Planning Committee Meeting

Wednesday, 15th September 2021

| 4.2 | KP-2021/152 - 15 Graham Road, Carrum | 19 |

This report is for Council to consider Planning Permit Application No. KP-2021/152 - 15 Graham Road, Carrum.

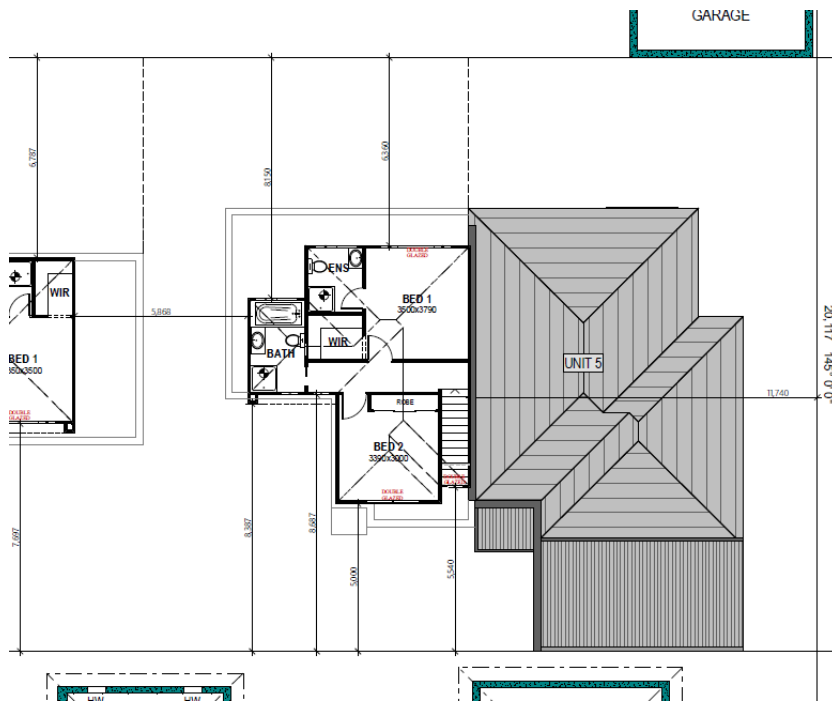
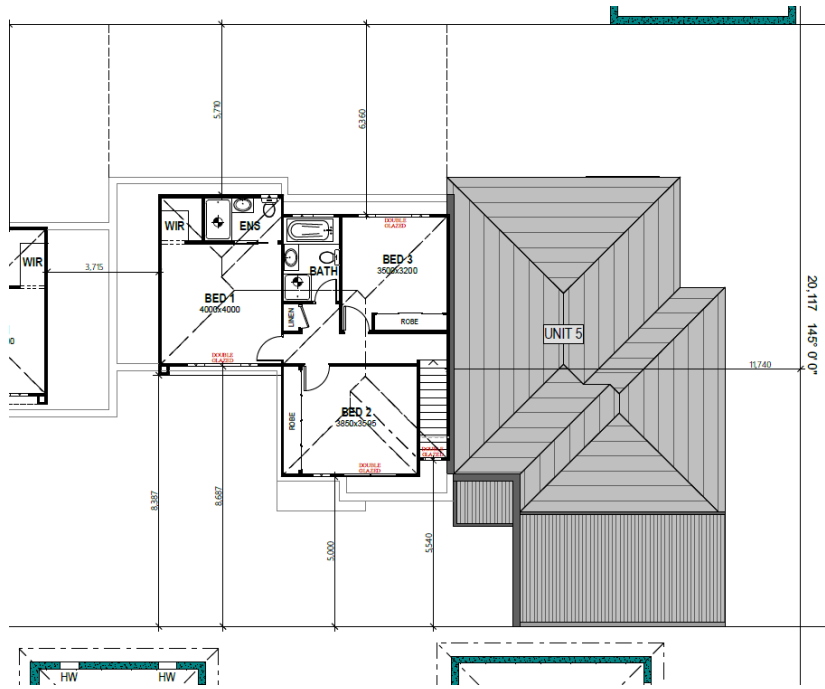
9.1 The plans were amended pursuant to Section 57A of the Act in response to Council and Objector concerns with car parking and built form/neighbourhood character. The changes include as follows:

A comparative snippet of the superseded and amended plans are provided below:

Proposal

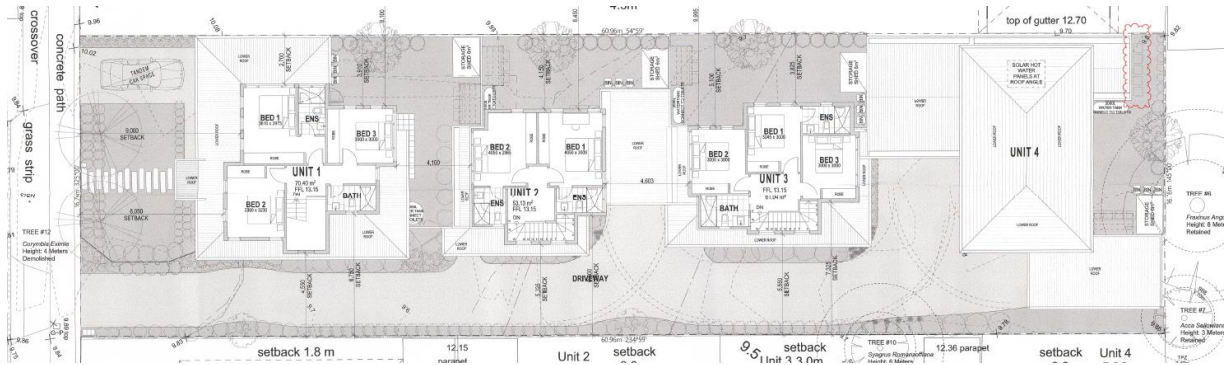
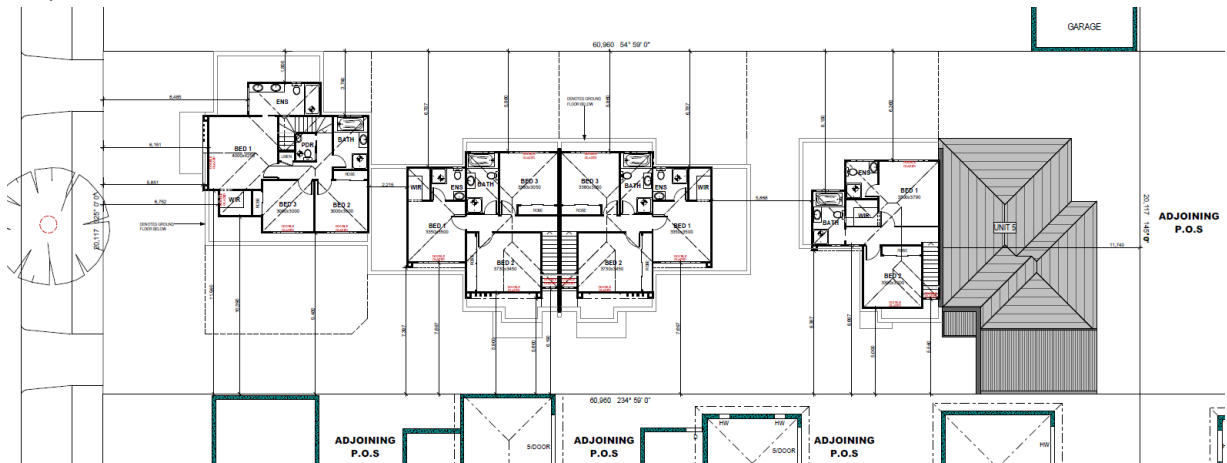
It is noted that the proposal will feature combined upper levels for Dwelling 2 and 3. This part of the upper level has again been designed to avoid visual bulk through its generous side setbacks of between 5.6m to 7.6m which exceeds the side setbacks of between 3.7m to 7.3m in the existing development examples provided above. Again, the combined upper level will have well-articulated walls through varying setbacks avoiding straight unbroken walls as well as sheer walls with the lower level. Varied materials and finishes together with architectural features have also been incorporated to minimise its visual impact as per outcomes sought under Council's Residential Development Policy.

Spacings are achieved between upper levels including 2.2m between Dwelling 1 and 2 and 5.86m between Dwelling 3 and 4. Together with the increased side setbacks, these breaks will provide sufficient visual relief when viewed from the adjacent south and north properties.

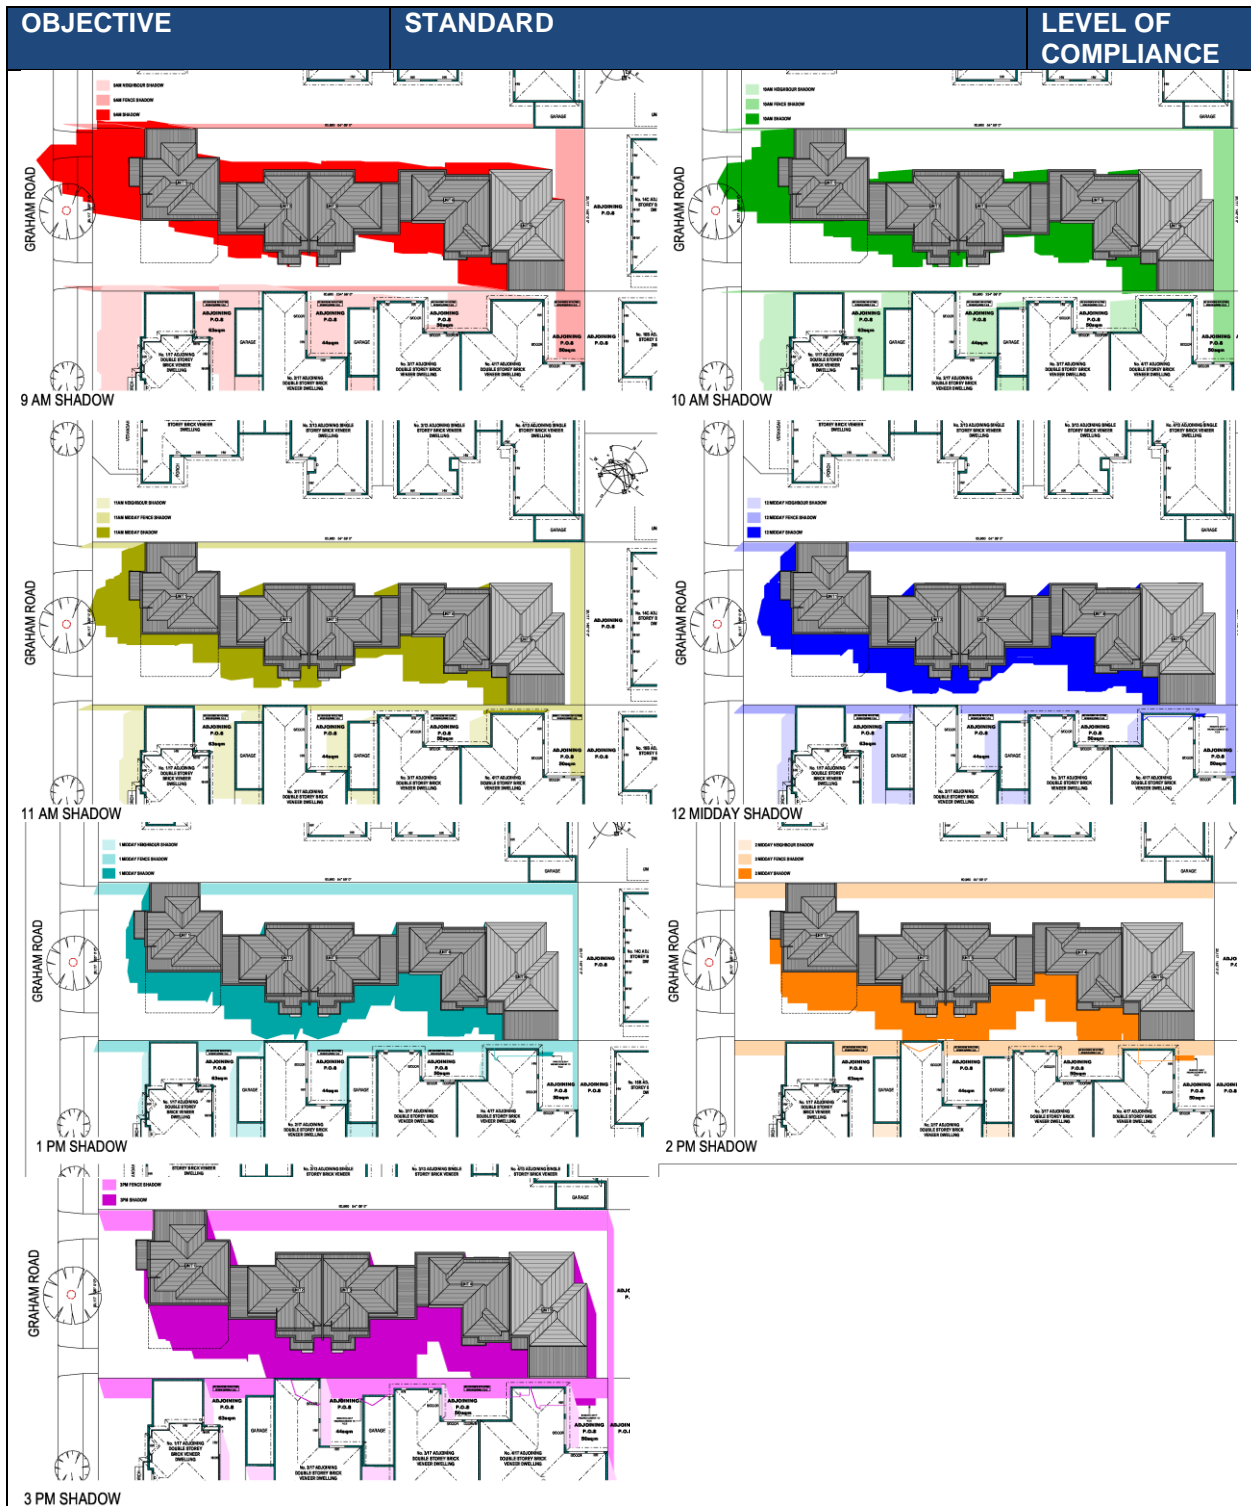
New shadows created from the development will mostly fall within the subject site and within existing shadow casts particularly boundary fencing. However, from 12pm there will be additional shadows cast into the SPOS of no. 4/17 Graham Road as a result of the Dwelling 5 garage wall on boundary. As shown below, the amount of additional shadow will range between 0.44 m² to 2.07 m², increasing slightly at each hourly interval between 12pm to 3pm. This amount of additional shadow is deemed negligible and will not be a significant level that will detriment the amenity of the SPOS. Despite this, the length of the garage 5 wall on boundary exceeds the minimum requirements and can be reduced by 500mm. Consequently, the shadows into the adjoining SPOS will reduce resulting in a minimum encroachment of 0.2 m² at 12pm and maximum 1.5m² at 3pm. Subject to the condition, the proposed shadow is acceptable and meets the objective of this provision. Refer to **condition 1 c**).

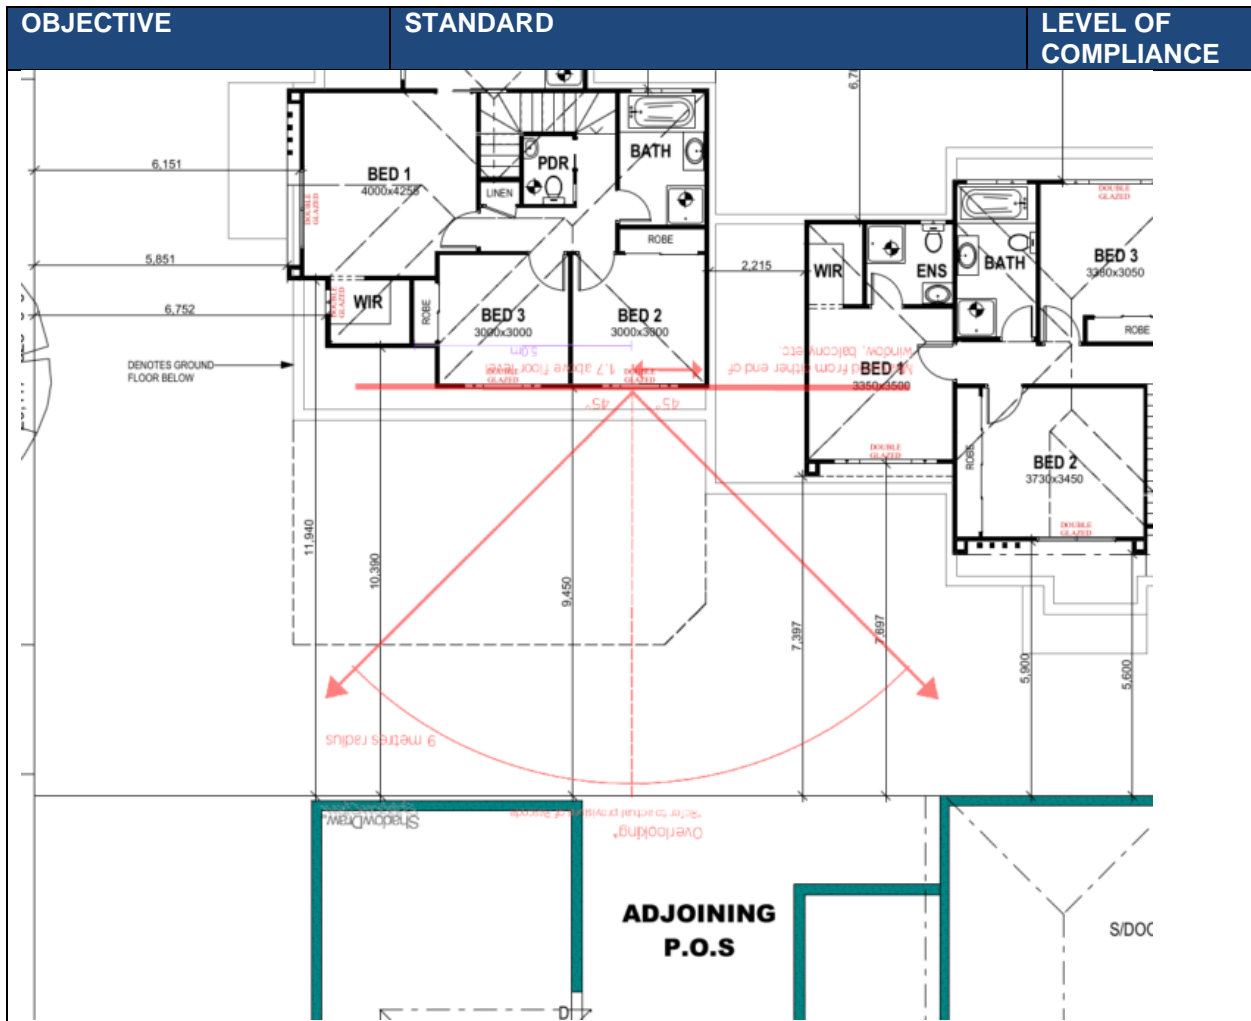
| OBJECTIVE | STANDARD | LEVEL OF COMPLIANCE |
|---|---|------------------------------------|
| <p>Assessment: All habitable room windows on the upper level of the proposed dwellings that will overlook adjoining SPOS and HRWs will be designed in accordance with the standard, specifically through the use of obscured glazing and external screens to a height of 1.7m above floor level.</p> <p>It is noted that the bedroom 2 and 3 windows of Dwelling 1 have not been designed in accordance with the standard as the adjacent SPOS is outside of the 9m overlooking arc as demonstrated below:</p> | | |

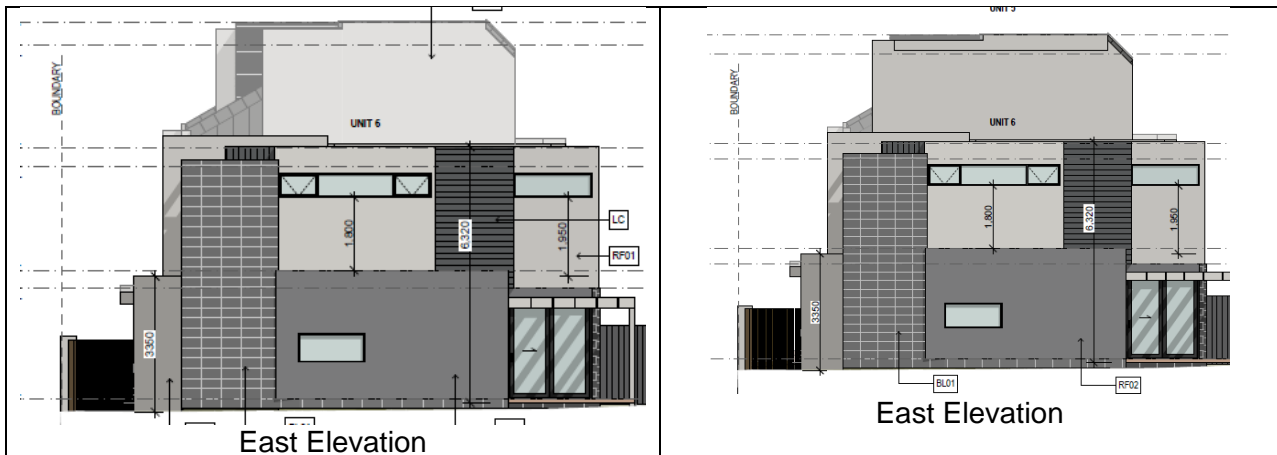
- 4.1 The section 72 amendment request by the applicant is for the plans only.
- 4.2 The proposed modification relates to dwelling 5 only. The proposal seeks to extend the uppermost floor to provide one additional bedroom. A comparison of the latest approved plans and proposed plans are shown:

4.3 The comparison between approved plan and proposed modification is highlighted below (in red):

South elevation showing treatment of wall as grey render.

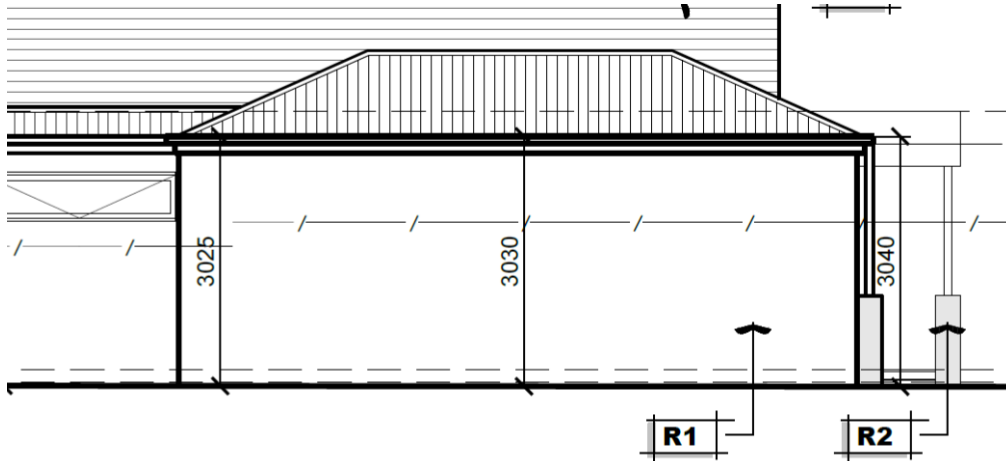
- 13.1 The objector concerns have largely been addressed in the body of this report. The remaining ground relates to the treatment of the south facing boundary wall which partially replaces the paling fence with No 49 Troy Street. The objector has sought that this wall be shown as rendered. A review of the plans indicates that this is the intention, noting that building access may be hampered by the existing boundary hedge.
